PLANNING & INFRASTRUCTURE DIRECTORATE

PLANNING PROPOSAL FOR 45 VICTOR STREET AND 410-416 VICTORIA AVENUE CHATSWOOD

ATTACHMENT 2

DETAILED ASSESSMENT

Figure 3 – Existing FSR under WLEP 2012

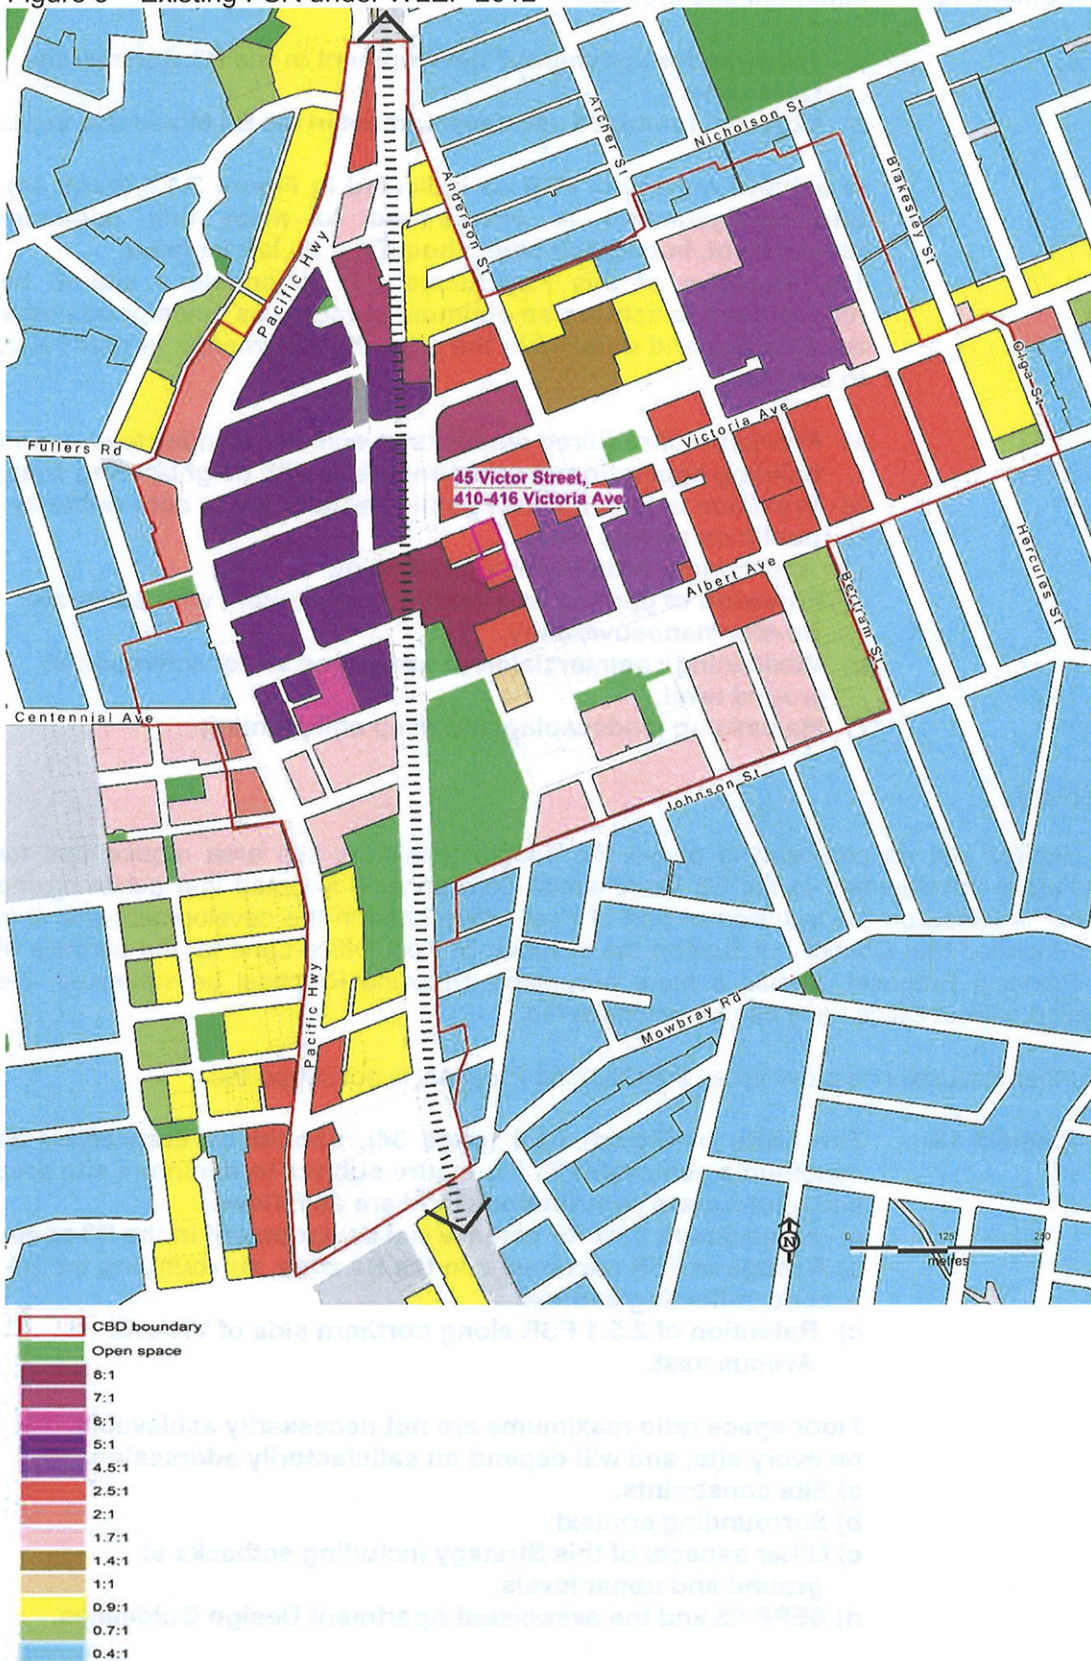
The subject site is in a location with a maximum floor space ratio under WLEP 2012 of 2.5:1 as shown below in Figure 3.

Figure 4 – Recommended maximum Floor Space Ratio

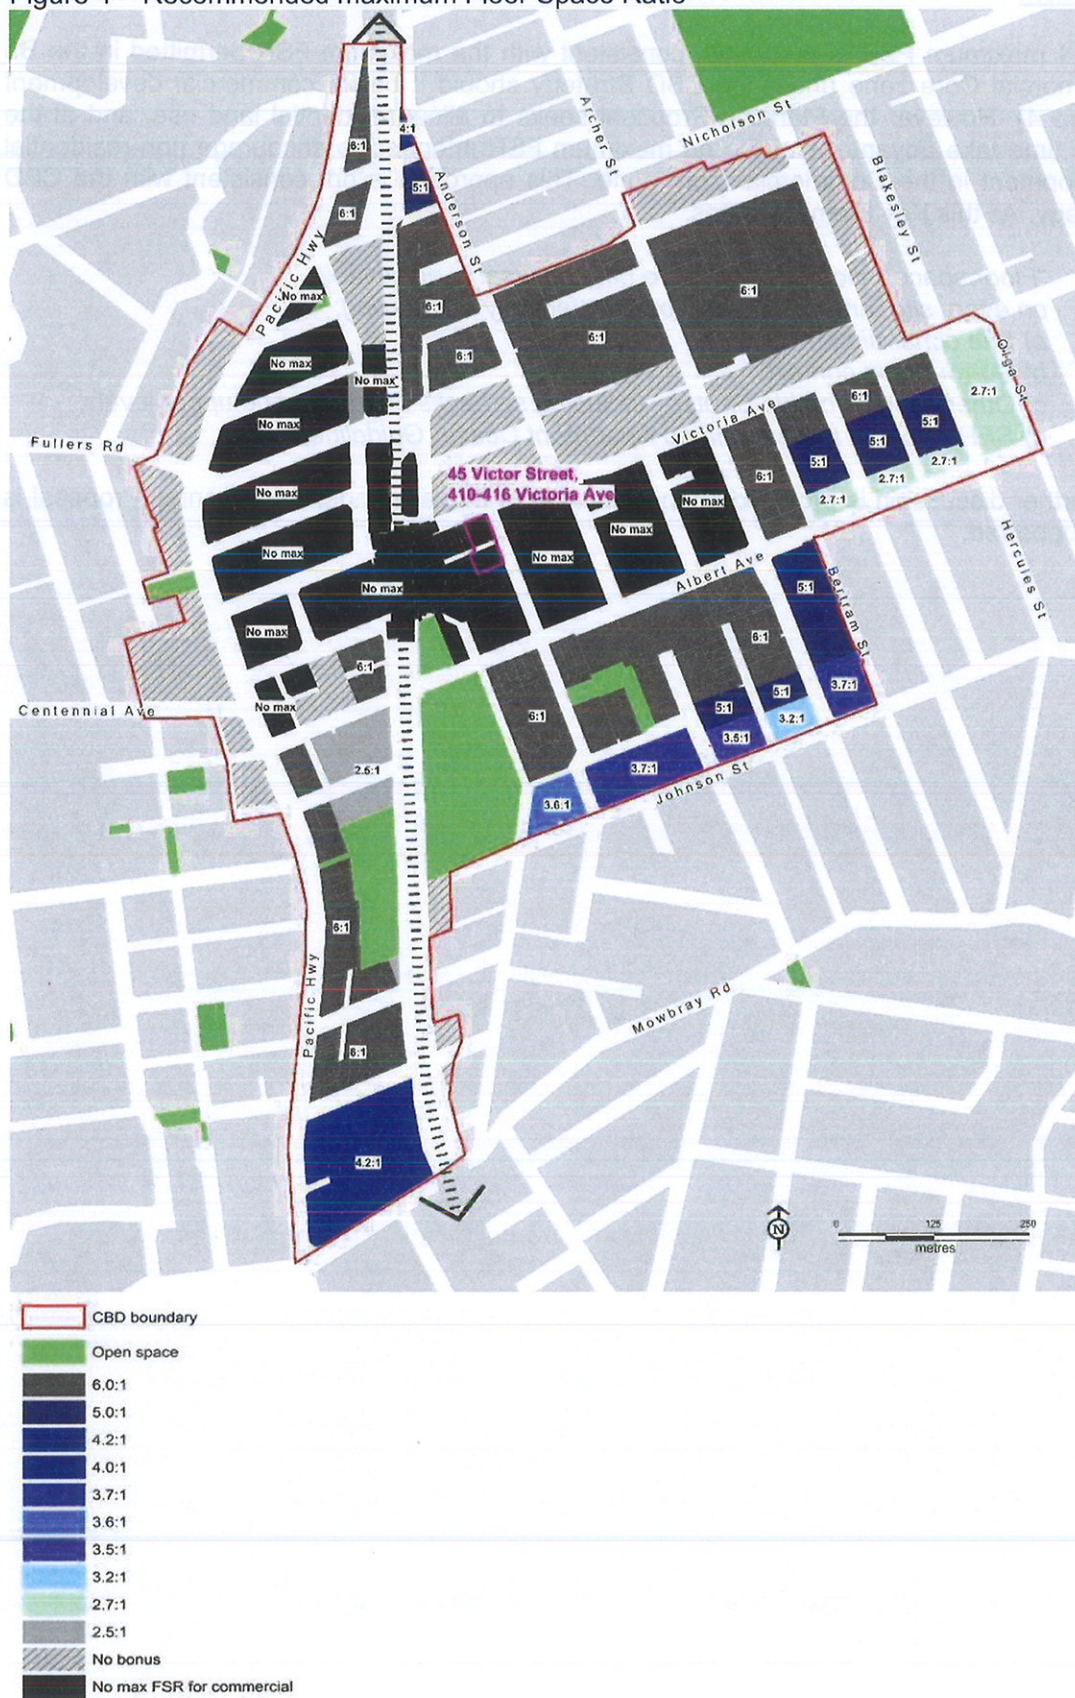
A 20:1 maximum FSR is proposed, consistent with the maximum FSR permitted in the B3 Commercial Core zone under the CBD Strategy should it be for commercial development (Figure 4). However the Planning Proposal seeks to allow residential land use, and at the same time take advantage of the no maximum FSR intended to encourage non-residential development in the Commercial Core zone. This approach is not consistent with the CBD Strategy. As this Key Element states:

Figure 5 – Recommended sun access protection for public spaces

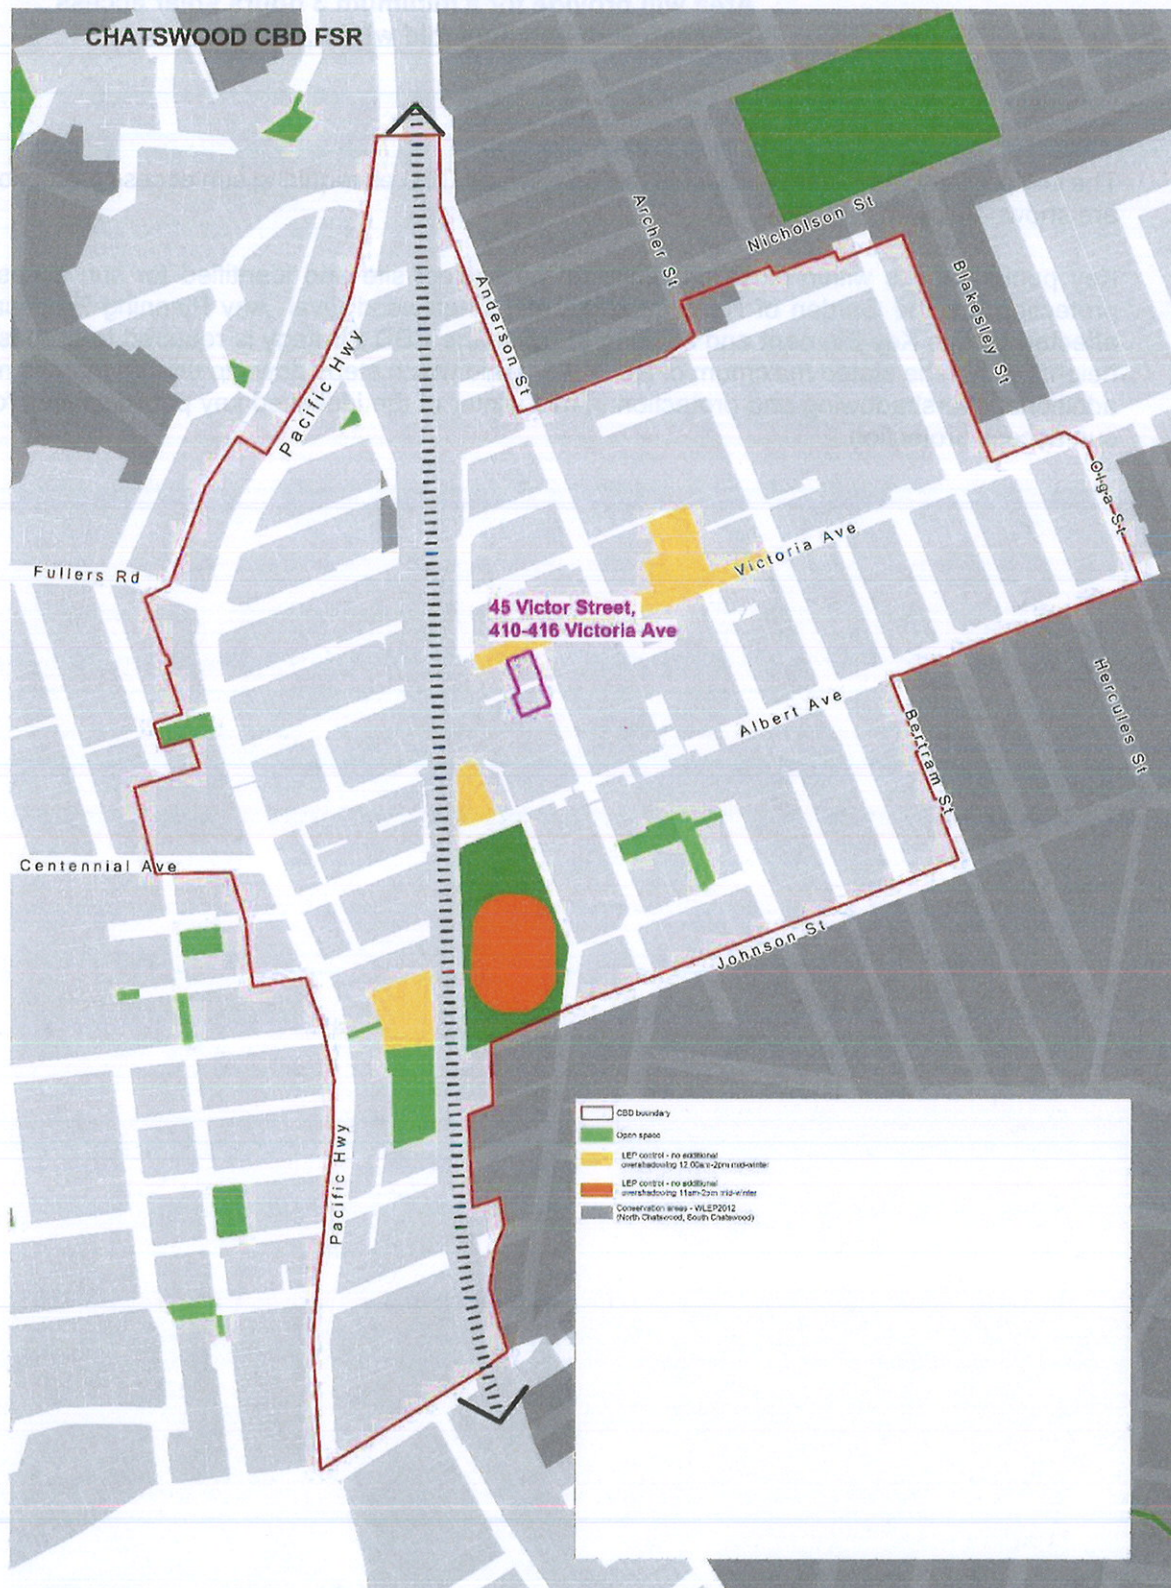
Key public spaces within close proximity to the subject site and identified for sun access protection are the Garden of Remembrance and Chatswood Oval. Any Planning Proposal affected by this Key Element and seeking to utilise the CBD Strategy is required to propose heights within the stated maximum of RL 246.8m and which steps down to ensure there is no additional overshadowing and protection in mid winter of the identified key public spaces for sun access protection.

Sun access to key public spaces and this Key Element is not discussed further as the Planning Proposal is not consistent with the CBD Strategy and is not supported.

Figure 6 – Recommended height

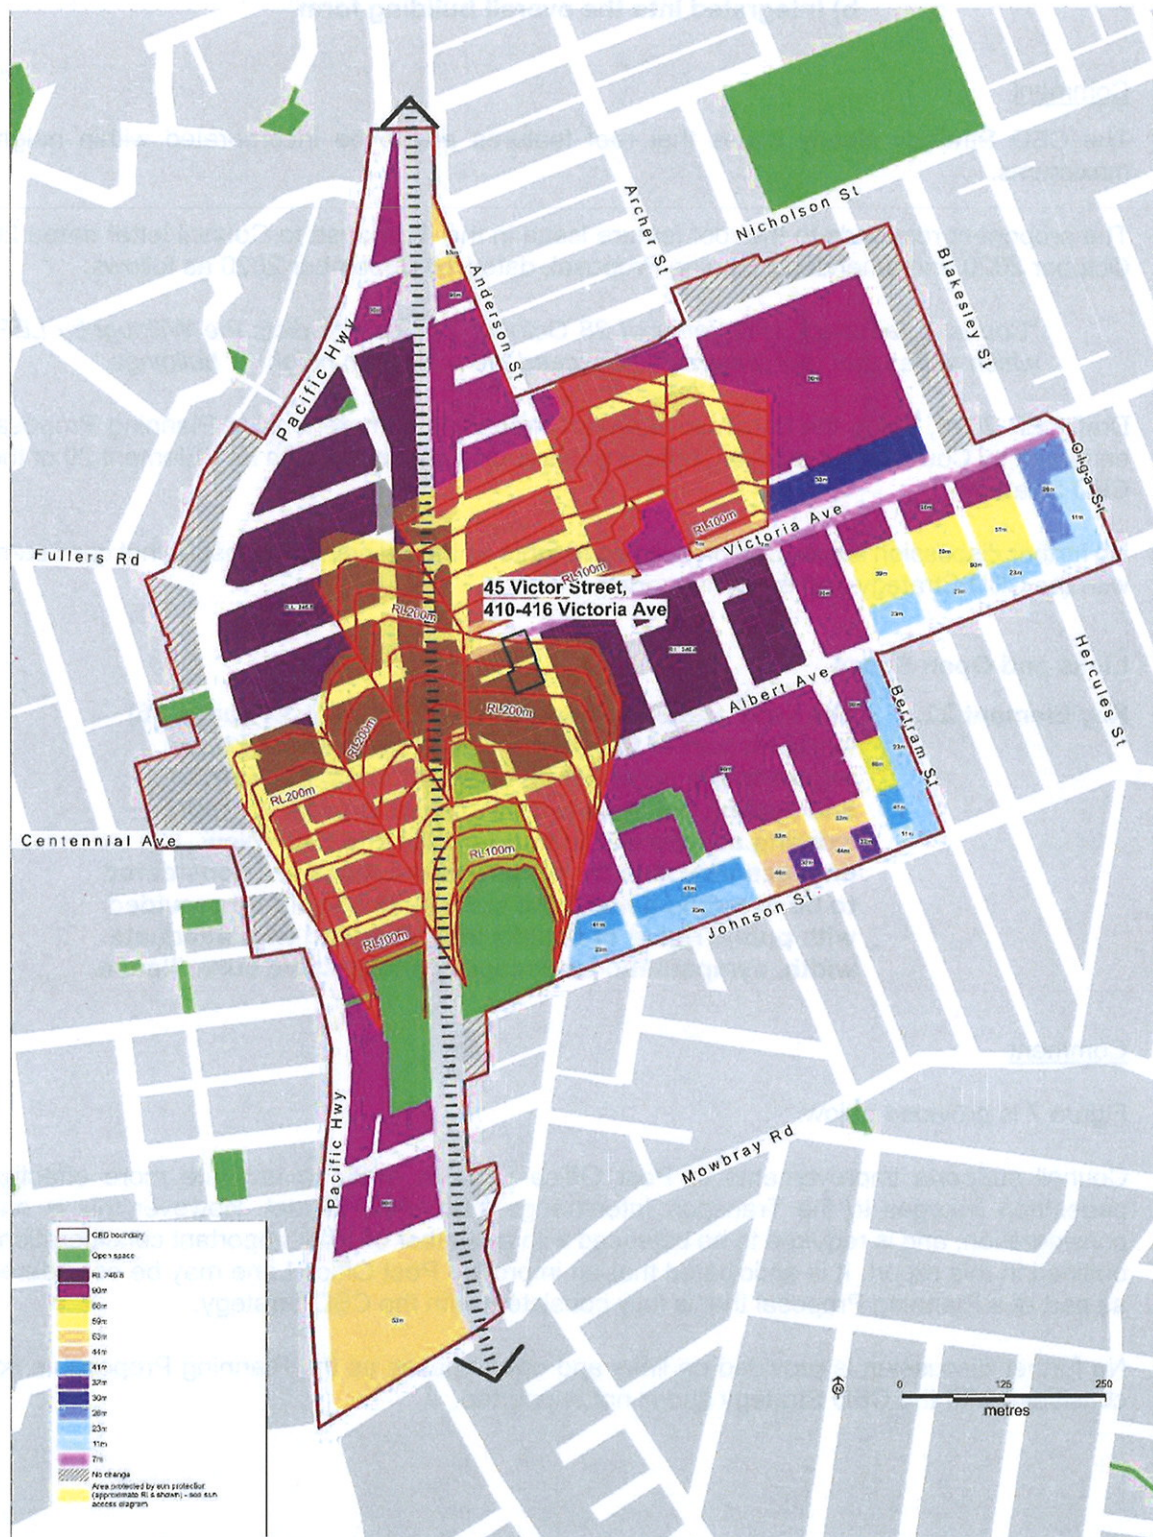
Figure 6 below shows the height maximums in the Chatswood CBD, including where height is to be reduced in order to achieve sun access protection to the public open space areas identified in Figure 5 (above).

Under the CBD Strategy a maximum height of 7m on the Victoria Avenue frontage, for a minimum setback of 6m, with a possible maximum of RL 246.8m on the remainder, is permitted (subject to other Key Elements such as land use, minimum lot size and setbacks being satisfactorily addressed). The Planning Proposal seeks a RL 262m height control over the entire site (with concept plans showing an additional 11.7m high roof feature zone making the total height RL 273.7m).

This means that height maximums require consistency with other Key Elements. An approach of consistency with some Key Elements and non-consistency with other Key Elements is not encouraged under the CBD Strategy.

Figure 7 – Recommended links and new open space

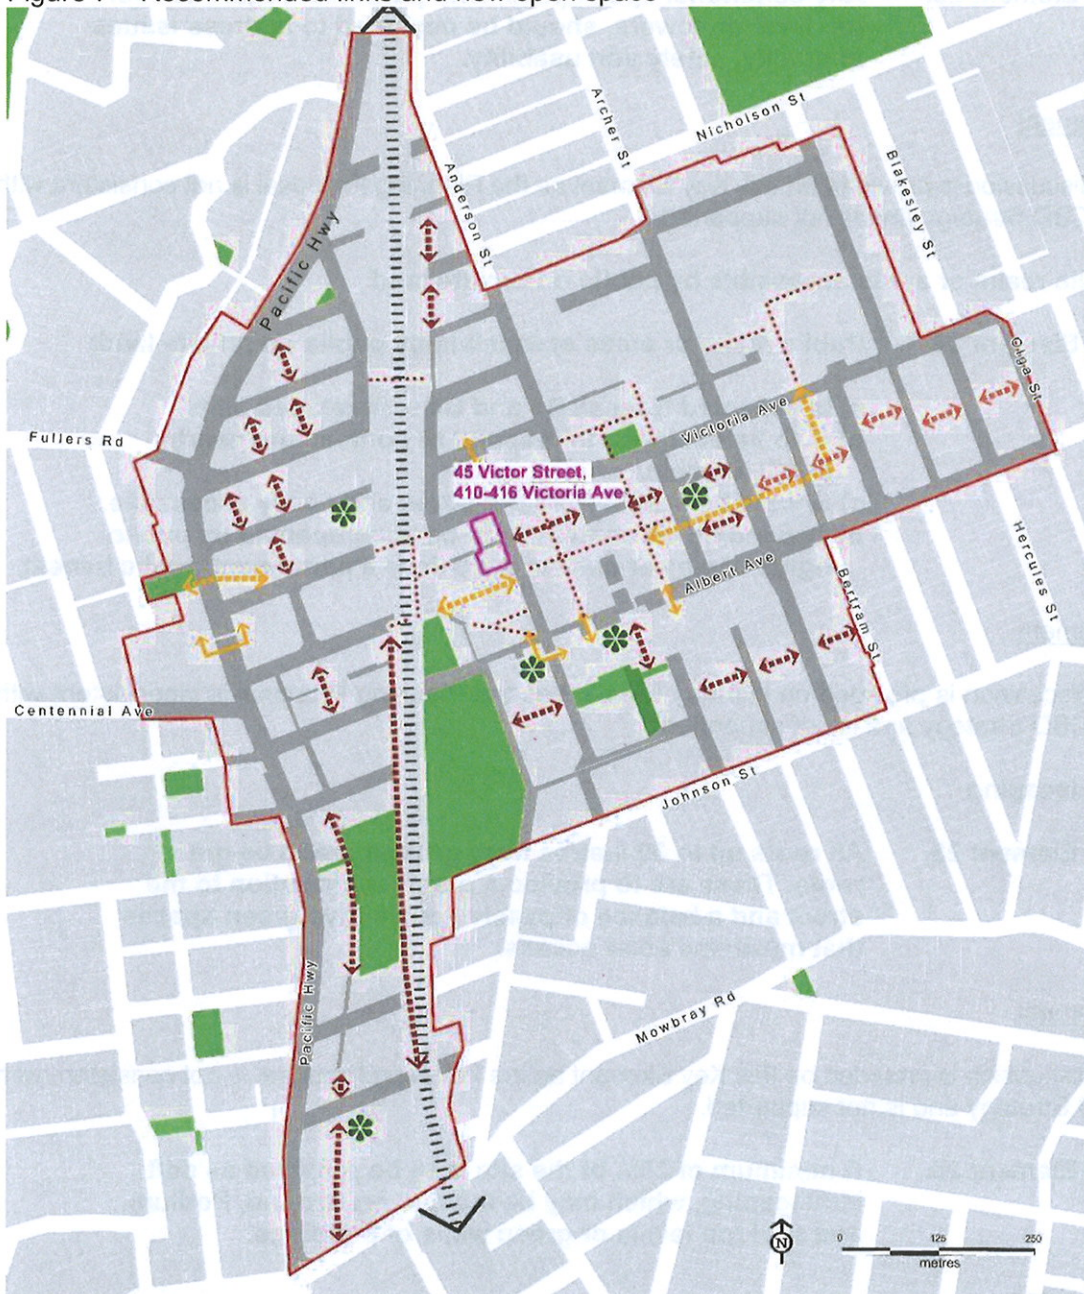
Council supports improvements to Post Office Lane in order to facilitate more effective pedestrian linkages to the Transport Interchange from Victor Street. However this is one consideration, and is required to be balanced with a number of other important considerations outlined in this report. It is anticipated that an improved Post Office Lane may be considered as part of a Planning Proposal that is fully consistent with the CBD Strategy.

No further discussion is provided on links and open spaces as the Planning Proposal is not consistent with the CBD Strategy and is not supported.
